# Burroughs

## M E C A N O G R A M

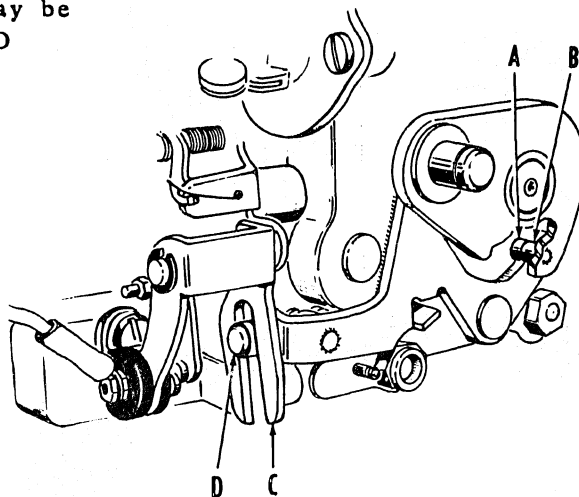
*1-BREAKAGE OF STUD B (81533C) may be caused by an early limit of roll D against the upper end of the fork portion of rocker arm C.*

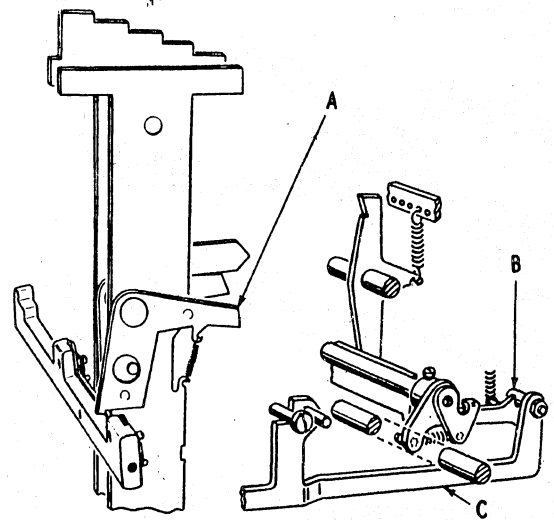
**1-CONTINUOUS MACHINE OPERATIONS IN SERIES M200 MACHINES** may result from failure of lift pawl A to be released before power indexing slide C is released. Inability to adjust for the proper timing relationship between the releasing of these two parts may be caused by the horizontal arm of the lift pawl being too long.

The arm of lift pawl A on cipher multiplier plate and full cent plate 1A-74107 No. 1 and on tens multiplier plates 1A-74107 Nos. 2, 4, 6, 8, 10, 12, 14, 16, 18, and subtract plate 1A-16 1/2A Fte. 134 has been shortened .015" beginning with Machine Serial No. M9029D so that eccentric screw B may be adjusted for releasing slide C after the lift pawl has been released.

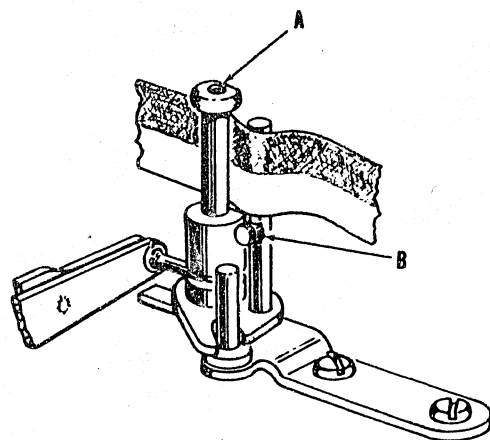
**2-FAILURE OF CARRIAGE TO RETURN** caused by the accidental movement of lever AC (Plate 31-5, Carriage Parts Catalogue) may be reduced by installing stronger spring 72833 in place of spring 7286 1/2, BG (Plate 31-5).

**3-PARTIAL BLACK AND RED PRINT CAUSED BY sagging of the ribbon on styles NA-2 and W2 carriages** will be corrected by installing improved ribbon guide post assemblies A (1-83205R and L) containing guide roller B.

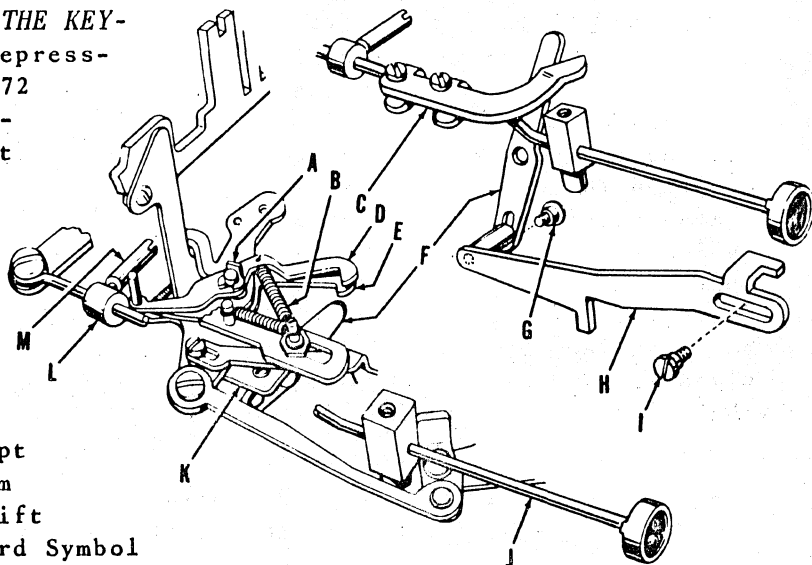
**1-EFFECTIVE LOCKING OF THE KEY-BOARD** from a partially depressed subtract key in Class 72 and Series M200 machines - without causing subsequent hard depression when fully depressing the key to index the power mechanism - will be provided by installing new auxiliary latch D.

The new latch retains arm F in position to lock the entire keyboard (except Clear Multiplier Key) from the time subtract plate lift pawl AB (Plate 30, Keyboard Symbol List) is released until latch E (illustrated) is positioned during the machine operation. The new auxiliary latch may be installed to facilitate adjustment of machines subsequent to Serial No. B46251. Parts are available.

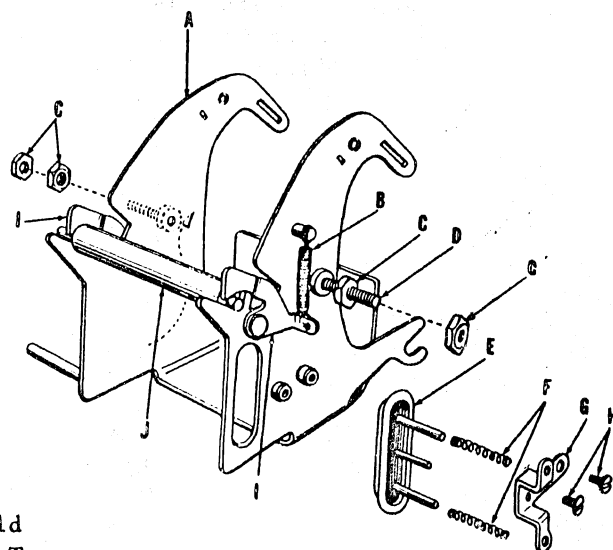
**1-SKEWING OF THE ROLL PAPER IN THE CARRIAGE** will be eliminated by installing the improved roll holder illustrated.

The improved holder contains pressure plate E which guides and controls the unreeling of the roll paper into the carriage. It also contains a threaded post D on each side to permit lateral alignment of the holder with the platen.

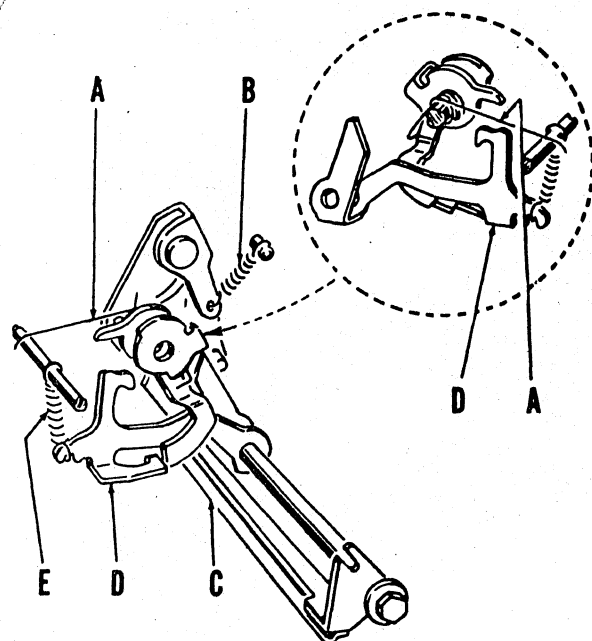
Spring A is assembled on the intermediate rack stop in the first column to assure more positive indexing of a carry.

Carry bail C is reinforced to prevent weaving, and lighter detent springs B and E permit easier action of the carry bail.

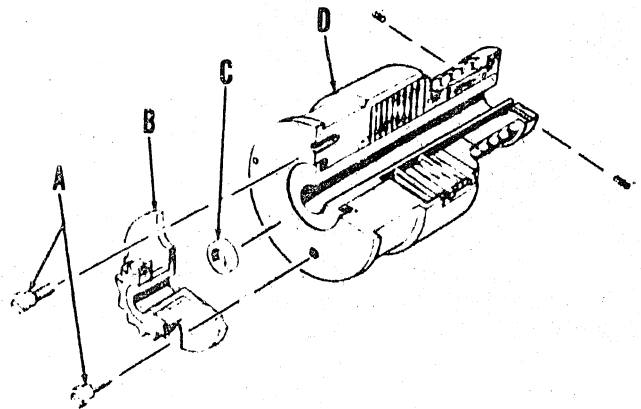
Increased movement of the switch arm has been provided by lengthening the formed end of lever AG (1-701274) so that it contacts the switch arm closer to its fulcrum. Stronger spring 44805 replaces spring AH to provide positive restoring of lever AG.

Install the lengthened lever and stronger spring when solenoid failure is experienced.

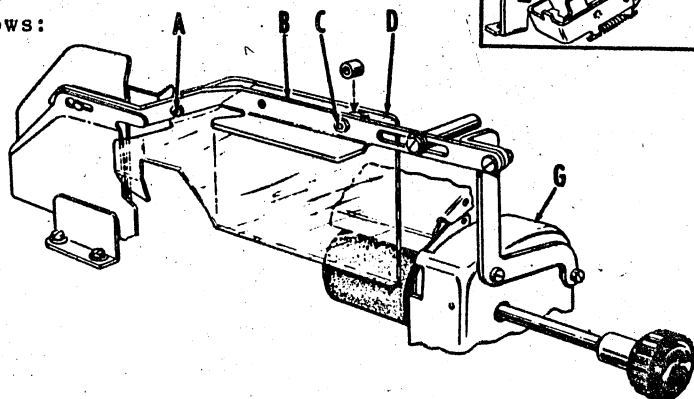
**1-WRONG PRINTING AND ADDING IN STYLE 1010304, BILL RECEIPTING MACHINES** - caused by the form guard and guide 16 (Plate 40, Carriage Parts Catalogue) interfering with movement of type bars - will be eliminated and form handling will be improved by installing the new guard and guide illustrated. Install as follows:

- Remove the tear-off blade and install spring anchor E for spring F formerly hooked to the tear-off blade. The spring extension should be bent upward for minimum clearance with cover G.
- Install the new guard and guide as shown.

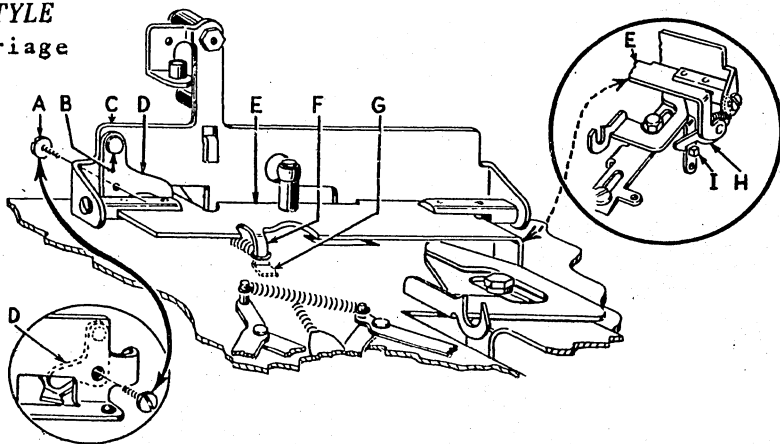
**1-FAILURE TO TABULATE, STYLE B CARRIAGES** (Plate 27, Carriage Parts Catalogue), may be caused by a broken extension (illustrated dotted line at G) of spring anchor F which positions tabulating bail E at normal.

Bail E is now constructed without the extension (solid line of F), and a new adjustable limit D is assembled as shown.

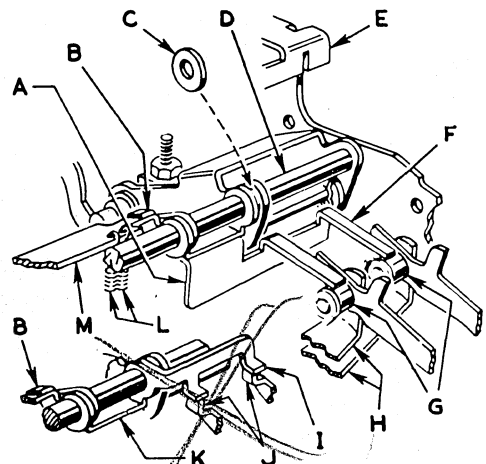
1-ADDING RACK BRACES A (1-86105 1/2 AR STYLE 13) - for 12 pitch construction - and K (~~86105 1/2R STYLE 13~~) - for 10 pitch construction - are now used in currently constructed Style 13 machines and may also be installed in Style 13 Field machines. The new braces prevent a possible wrong addition that results from excessive movement of adding racks H in columns 1 and 2 during a machine operation in which these adding racks are inactive.

During subtract operations, as the lower wheels move into mesh, the excessive side weave of inactive racks H may cause a counterclockwise turning of the lower wheels. Such movement of the lower wheels (in cipher position) may result in the initiating of a carry through the tripping of one or more carry pawls.
